PLANT HATCH - UNIT 2

NRC DOCKET 50-366

RESOLUTION OF HUMAN ENGINEERING DEFICIENCIES

PLANT HATCH - UNIT 2 NRC DOCKET 50-366 OPERATING LICENSE NPF-5 RESOLUTION OF HUMAN ENGINEERING DEFICIENCIES

LOCATION OF CHANGES TO PANEL 2N62-P600

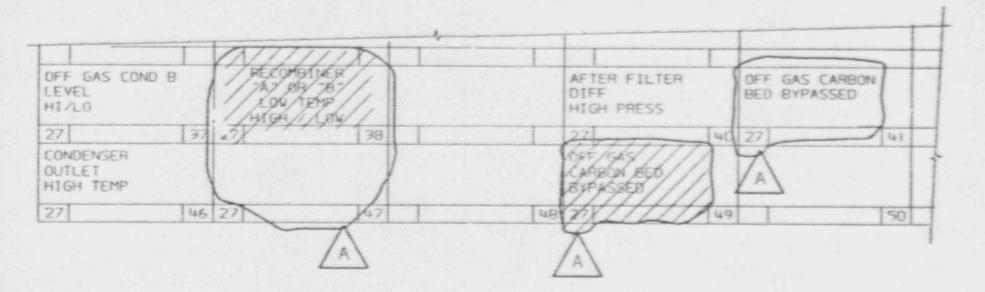
Move the offgas carbon bed bypassed annunciator and the recombiner A or B temp hi/low annunciator to group the alarms with related systems, similar to the Unit 1 arrangement.

It should be noted that the annunciators, in their existing configuration, are not grossly out of position with respect to other related annunciators or their respective systems and controls. For example, an operator working at the off-gas panel (Figure 2) can respond to the recombiner A or B temp hi/lo annunciator from its present position just as easily as he can from the proposed position. As shown in Figure 3, four annunciators related to primary containment isolation system vent valve overrides are to be moved from one side of the annunciator panel to the other. The associated controls for the annunciators are located directly under the panel. If an operator were to override the high drywell pressure signal for one of the vent valves using the keylock switch, he could verify this action by looking at the alarming annunciator on the 2H11-P654 panel. Soving the annunciator to its proposed location will not improve the operator's ability to make the verification.
